SUBJECT: SALEM NUCLEAR GENERATING STATION, UNITS 1 AND 2 (TAC NOS. M86266 AND M86267)

SAFETY EVALUATION BY THE OFFICE OF NUCLEAR REACTOR REGULATION  
RELATED TO AMENDMENT NOS. 164 AND 145 TO FACILITY OPERATING

SALEM NUCLEAR GENERATING STATION, UNIT NOS. 1 AND 2

DOCKET NOS. 50-272 AND 50-311

**2.1 DESCRIPTION OF SALEM CONTROL AIR SYSTEM**

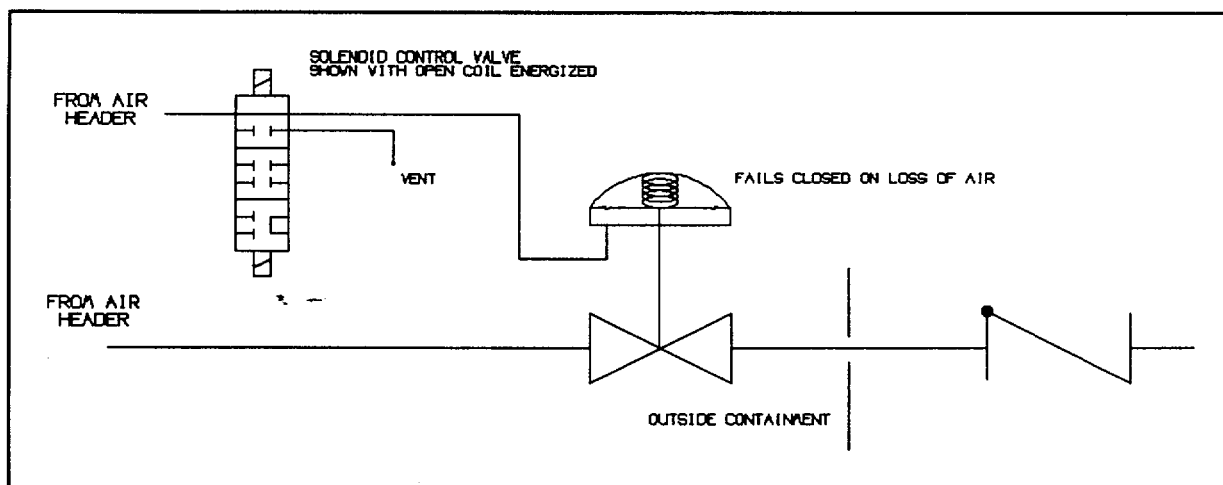
Each of the 2-inch control air header containment penetrations has two isolation valves: (1) a check valve (CA-360) located inside containment and, (2) an air-diaphragm operated, solenoid-controlled valve (CA-330) located outside containment. The design of CA-330 is such that it will open when air pressure is applied to its air operator. When the air pressure is released, it will close under spring action. Application of air pressure to, or venting of air pressure from each CA-330 operator is controlled by a pilot solenoid valve. The solenoid valves are energized from a panel that is powered from a 125 VDC vital power bus. The air supply for each CA-330 air operator is taken from its associated air header. The CA-330 valves are designed to close on a Phase A containment isolation signal. Control air is not required in containment to mitigate a design basis accident (DBA) as the equipment using control air will fail to the accident position on loss of control air.

The solenoid valves that control the CA-330 air operators are three-way valves, each having two 125 VDC coils. One coil, when energized (the normal condition), causes control air pressure to be applied to the associated CA-330 air operator in the open direction. The other coil, when energized, causes the solenoid to vent the air operator allowing the valve to close. If neither coil is energized, the solenoid valve ports are sealed and the isolation valve is locked in its current position. Should a DBA occur, the Phase A isolation signal resulting from high containment pressure will apply 125 VDC power to the close coil which shifts the solenoid valve to the position that vents air from CA-330 air operator diaphragm.

The staff has examined the design of the isolation system for the control air header piping penetration. With the exception of the failure position for valve CA-330 on loss of its 125 VDC power supply, the design meets all applicable criteria. Failure of the 125 VDC power supply results in a slight degradation in containment isolation reliability. Upon failure of the 125 VDC power supply, the valve will remain in the "as is" position. Since the valve is normally open, this means that the valve will stay open and will not close on an isolation signal. For all other single failures, the valve will automatically close upon either loss of air or an isolation signal.

The staff has evaluated the conditions for the "as is" failure and finds that the reduction in safety margin due to this condition is acceptably small. First of all, there is a check valve in series with the air operated valve so that containment integrity is maintained at all times. Secondly, the probability of loss of air pressure is quite low since the normal air supply is backed up with a safety grade supply which is activated automatically upon sensing low air pressure. With an operable air supply, the penetration is not a containment leak path since the air pressure is greater than the peak calculated containment pressure.

Although the valve does not fail in the position of greater safety (an SRP 6.2.4 criterion) for a loss of 125 VDC power supply, the staff finds the degradation acceptably small for the reasons provided above.
